BULLETIN NUMBER:
IB12-N-001A

No Crank/No Start, No Scan Tool Communication – Extreme Cold Weather

- 2007-2014MY Isuzu N-Series
Equipped with 5.2L (4HK1) Diesel Engine and Diesel Particulate Filter (DPF)

Figure 1
Locate X-30 relay and relay cover rib

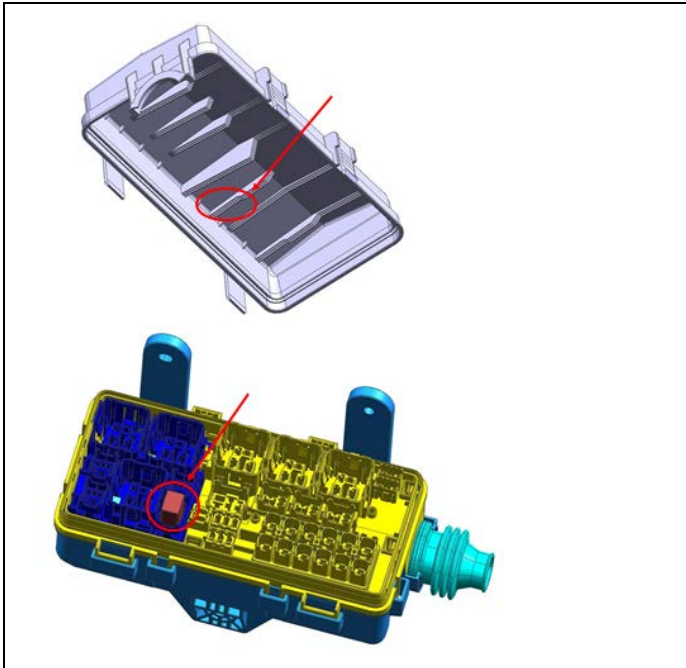
1. Remove relay box cover.
2. Remove the original ECM Main Relay in location X-30.
3. Install the new relay at location X-30.
4. Locate the relay box cover rib as shown in figure 1.

Figure 2
Cut at dashed line

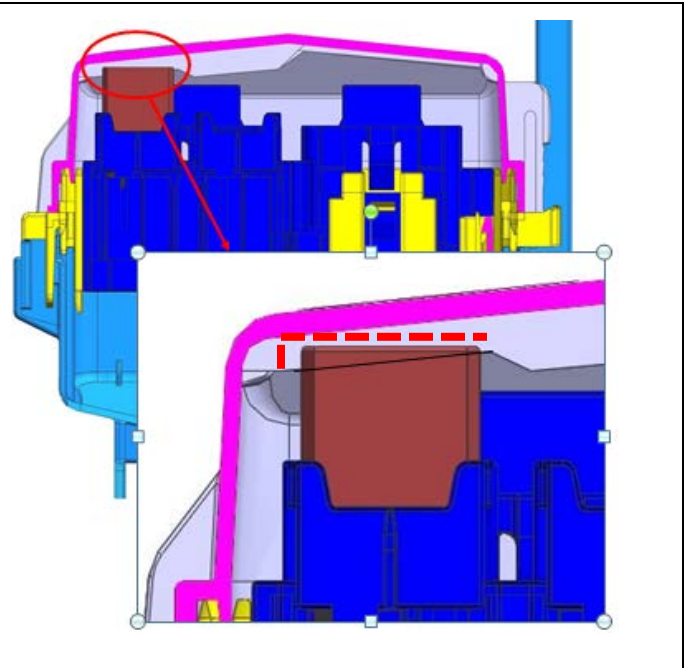
5. Trim the relay cover rib approximately 3 mm to provide clearance for the new relay.
6. Install the relay cover and confirm it seals properly. If the cover does not close properly, trim additional material from the cover until it seals.
